CRIME IMPACT STATEMENT

LAND AT PARKHOUSE STREET/KELBROOK ROAD, OPENSHAW, MANCHESTER
INDUSTRIAL BAKERY WITH ANCILLARY OFFICES, PARKING & SERVICING

FOR: Sheldon's
VERSION A: 09/06/2025
REFERENCE: 2025/0178/CIS/01

URN: 2025/0178/CIS/01

1 Visual Audit

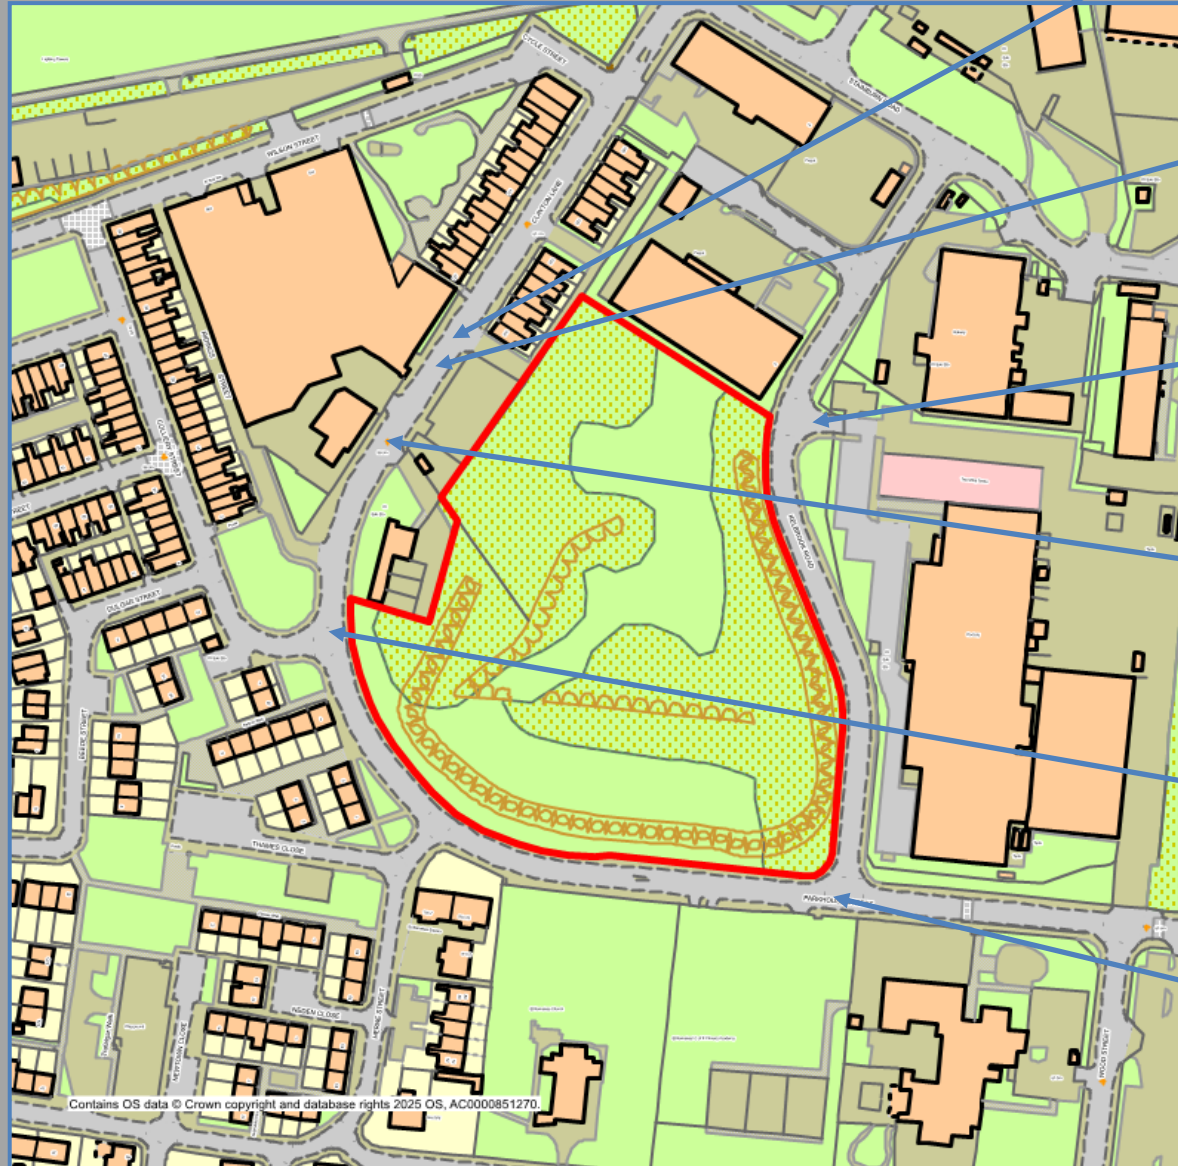
The site is bounded by Parkhouse Street to the south, Kelbrook Road to the east and Clayton Lane to the west, in the Openshaw area of east Manchester. It is currently formed by vacant open space with dense vegetation and mature trees. There are signs of disorder, such as flytipping, which can often occur when an offenders presence is unlikely to attract attention and a place feels like it is not under supervision. If signs of disorder are not repaired/removed immediately, they can often attract further abuse and trigger a downward spiral of neglect and loss of environmental quality - giving the impression that crime and disorder is tolerated.

To the east of the site (on the opposite side of Kelbrook Road) and to the immediate north are industrial sites enclosed with high Palisade fencing/gates, which provide little activity along or overlooking over the street. The existing Sheldon's factory lies to the north-east.

To the south of the site is St Barnabas Primary School and playing fields (fronting onto Wood Street) and Grace Life Church and grounds (fronting onto South Street), which again provide little direct overlooking over the street and the site itself.

Along the immediate western boundary of the site is a large electrical substation, a used car sales compound and terraced housing (with gated rear access alleyway) fronting onto Clayton Lane, with a car servicing garage and industrial buildings on the opposite side of the street. These buildings have been heavily fortified with shutters and barbed wire – indicating the presence of crime and disorder issues.

To the south-west of the site, on the opposite side of Parkhouse Street are residential properties in a Radburn style layout, featuring pedestrian routes separated from vehicular movement (often to the rear of dwellings), communal areas of landscaping and communal parking areas remote from the dwellings they serve. This type of layout can result in a lack of definition between public and private space, creating areas which can attract nuisance, anti-social behaviour and criminal damage. The networks of the pedestrian access routes through such estates often make them extremely permeable and also provide easy access/escape routes for criminals to utilise – particularly those which benefit from little/no natural surveillance and are likely to be infrequently used.
